## **Access Compliance Report Public Rights-of-Way** (Curb Ramps)

Intersection ID: 50613 Main Street: BALSAM BAY RD Cross Street: DOWNY\_BIRCH\_RD Location: NW **Overall Compliance: No ADA ID: 874EACECADF5** Ramp Type: Perp Initial Pass/Fail: Pass **Severity Score:** 5.25

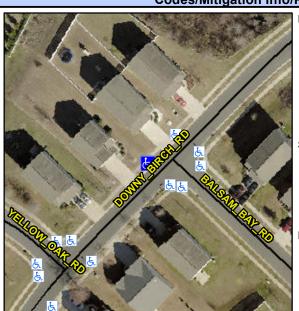
Possible Solutions: Remove & Replace Entire Ramp. Remove & Replace Gutter. Surveyor Notes: N/A PROW/ADA: Not Found, R304.5.3, R305.2, R304.5.4

Field Measurements/Component Compliance						
Compliance Description D		Data	Comp	oliance Description	Data	
N/A	Ramp Length (in)	46.5	Yes	Ramp Slope (%)	5.6	
Yes	Ramp Width (in)	48.0	No	Ramp XSlope (%)	3.2	
N/A	Flare Type LT	Sloped	N/A	Flare Type RT	N/A	
N/A	Flare Slope LT (%)	7.8	N/A	Flare Slope RT (%)	0.9	
N/A	Flare Traversable LT?	No	N/A	Flare Traversable RT?	No	
Yes	Landing Length (in)	48.0	Yes	DWS Provided?	Yes	
Yes	Landing Width (in)	48.0	Yes	DWS Contrast?	Yes	
Yes	Landing Slope (%)	1.7	Yes	DWS Length (in)	24.0	
No	Landing X Slope (%)	3.5	Yes	DWS Full Width?	Yes	
N/A	Landing Curb? (Y/N)	No	No	DWS Offset (in)	3.5	
N/A	Shared Landing?	Yes				
Yes	Gutter Ponding?	No	No	Gutter Slope (%)	10.5	
Yes	Gutter Lip Ht (in)	0.0	No	Gutter X Slope (%)	3.2	
N/A	Painted X Walk1?	No	N/A	Painted X Walk2?	N/A	
	X Walk 1 Direction	To S		X Walk 2 Direction	N/A	
N/A	X Walk 1 Width (in)	N/A	N/A	X Walk 2 Width (in)	N/A	
	X Walk 1 Slope (%)	3.2		X Walk 2 Slope (%)	N/A
